RE: VICTORIA TO NEW SOUTH WALES INTERCONNECTOR WEST (VNI West) REGULATORY INVESTMENT TEST FOR TRANSMISSION (VNI West RIT-T)

SUBMISSION ON VNI WEST PROJECT ASSESSMENT DRAFT REPORT (VNI West PADR)

Figure 1 Preferred option for Western Victoria Renewable Integration RIT-T

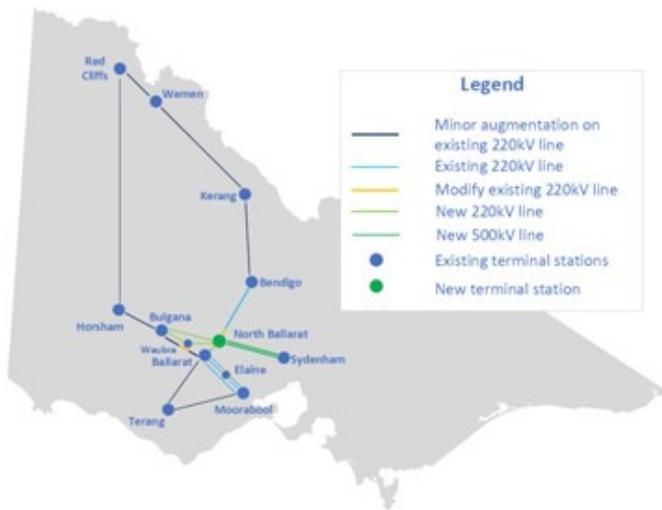
Given the inclusion of these VNI West Components in the West Vic RIT-T preferred option, and the fact that the WVTNP, now WRL, had been contracted out in December 2019, it is surprising to the Alliance that in the VNI West PSCR published in the same month, a greater range of credible options were proposed to be investigated in the VNI West RIT-T. For the routes of the various credible option see Figure 1 reproduced below.⁷ Note that from this point on, the WRL project from Sydenham to Bulgana is shown in all plans as a committed and/or anticipated project.

Figure 1 Credible options assessed

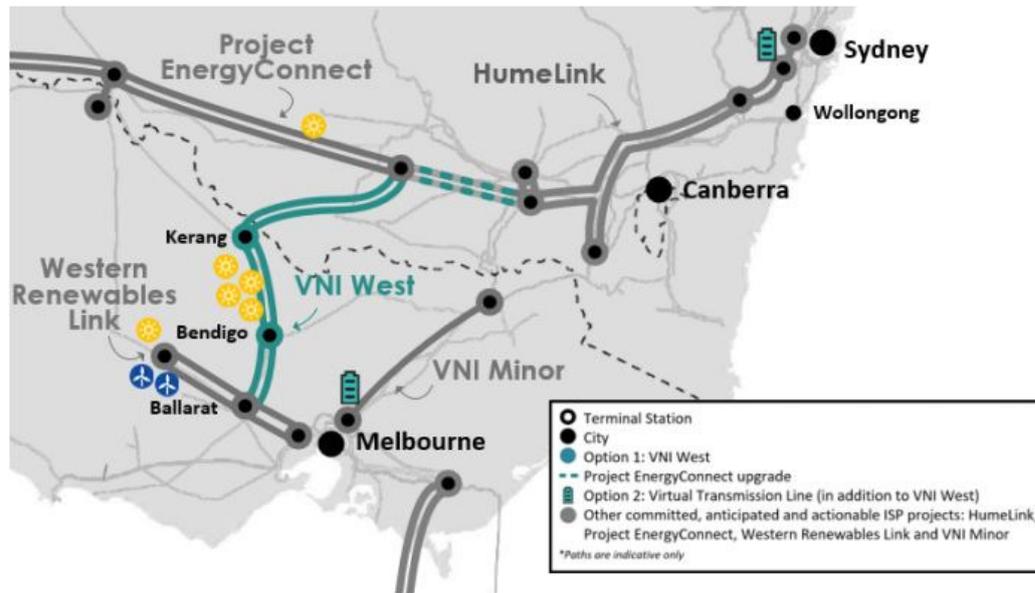
It is clear from this Figure 1 that the VNI West interconnector (for the purpose of the VNI West PADR) commences at the NBTS proposed to be built as part of the WRL (a project that is still in the early stages of the EES approval process) and that it will rely on the double circuit 500kV line proposed to also be built in the WRL to reach Sydenham.

VNI West is intended to run to the state border via new terminal stations proposed to be built at Bendigo and Kerang as part of preferred option 1 in the VNI West PADR. The proposed interconnector then proceeds over the border to a new terminal station at Dinawan to Wagga Wagga via an upgrade of Project EnergyConnect (the stage in which this upgrade is proposed – the line connecting the Buronga and Wagga Wagga substations – is currently progressing through an EIS approvals process).
